MILLSTONE NUCLEAR POWER STATION

JANUARY-JUNE 1990

CHANGES TO THE RADIOLOGICAL EFFLUENT MONITORING AND OFF-SITE DOSE CALCULATION MANUAL (REMODCM)

MILLSTONE OFFSITE DOSE CALCULATION MANUAL CHANGE REQUEST #90-1

*FIGURE G-1
 Inner Air Particulate and
 Vegetation Monitoring Stations*

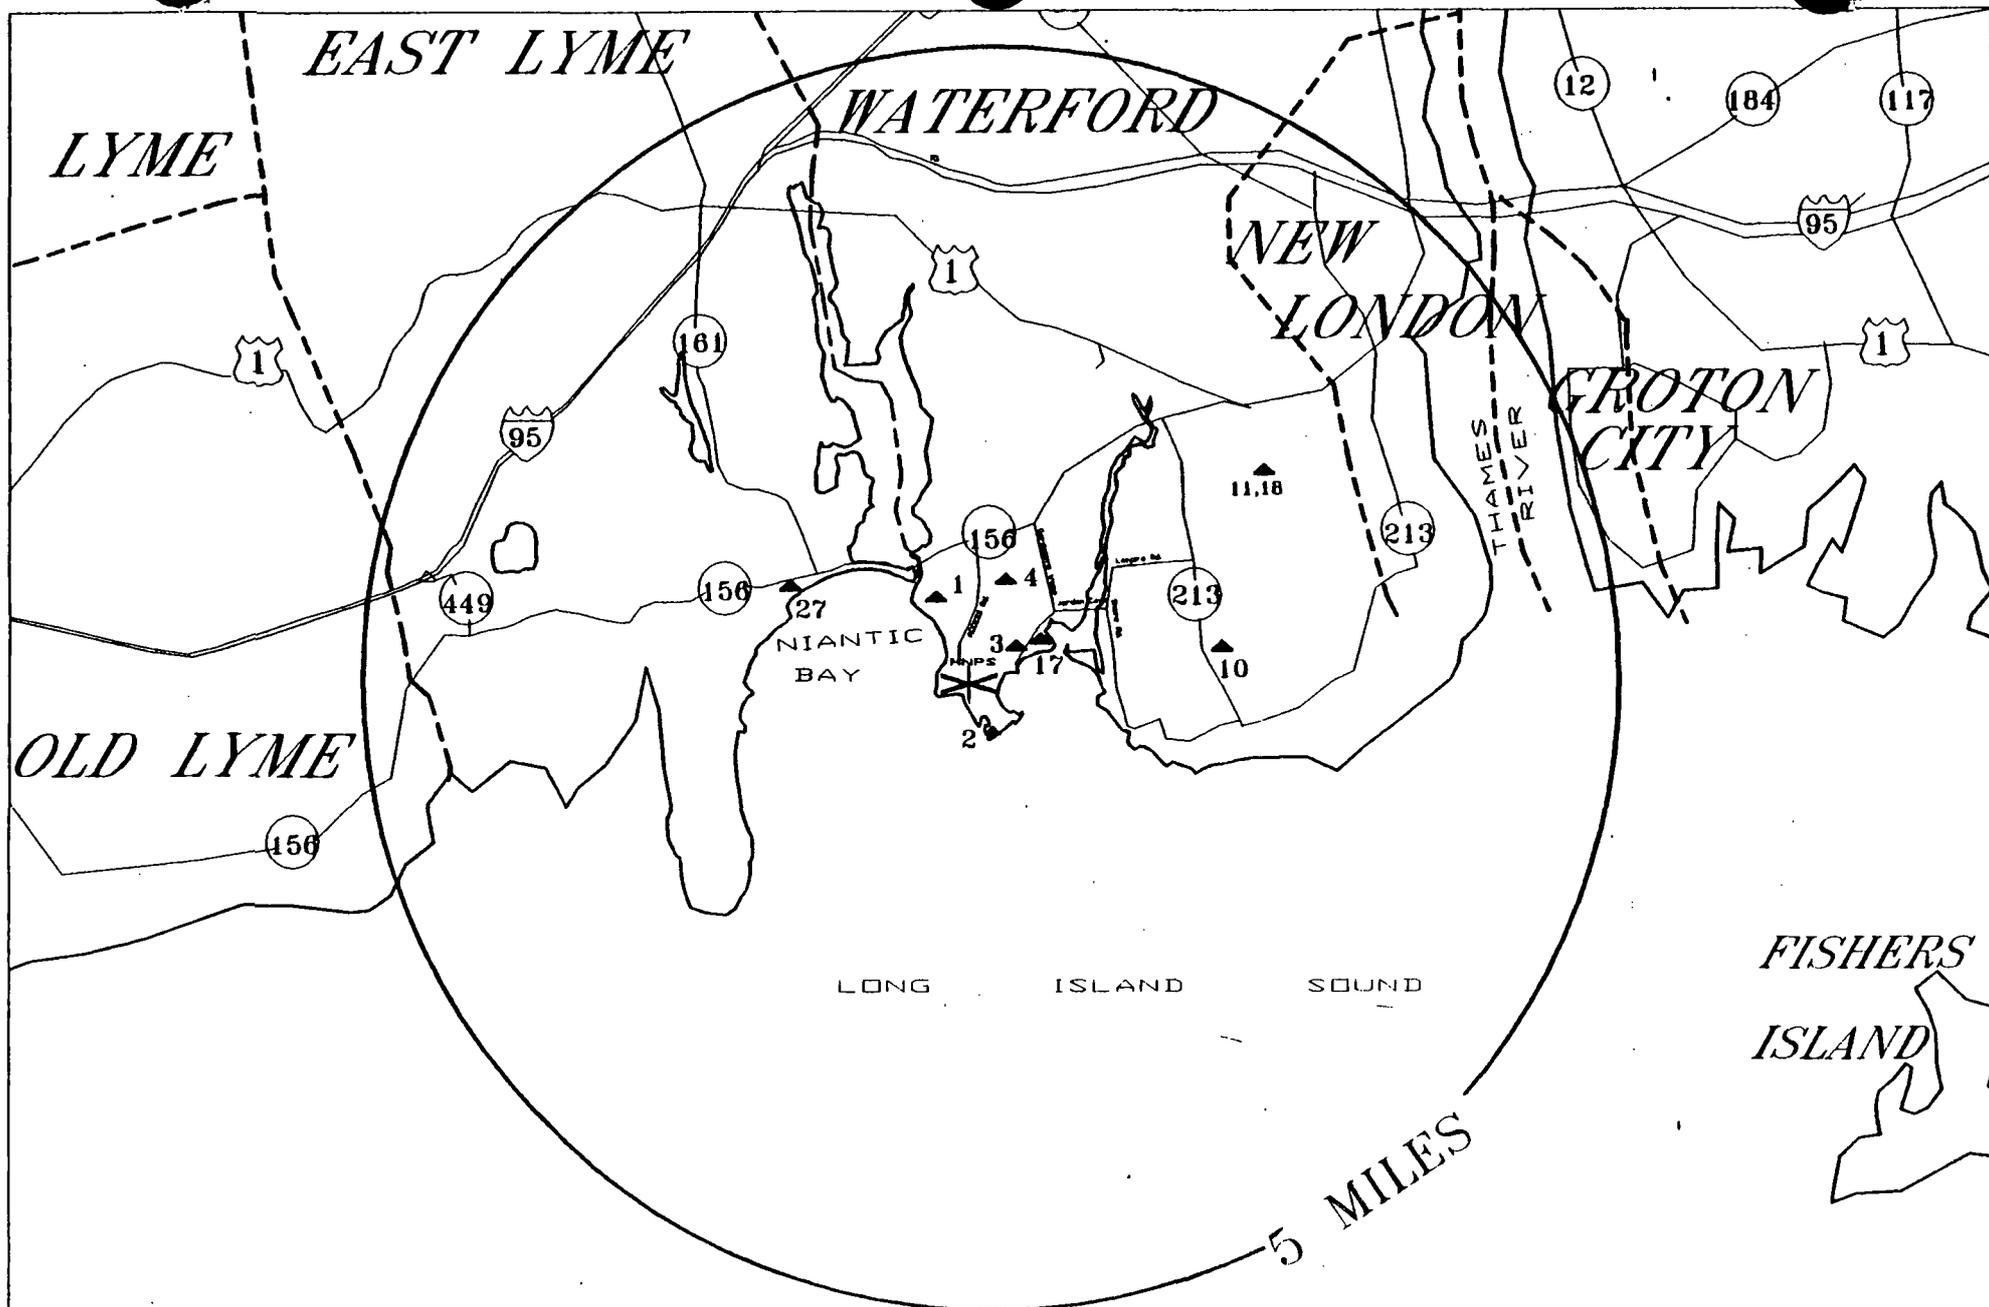
- Figure G-1 Redone for clarity.
- Figure G-2 Redone for clarity and addition of milk locations.
- Figure G-3 Redone for clarity.
- Appendix H Deleted since requirements for sampling this pathway were deleted.
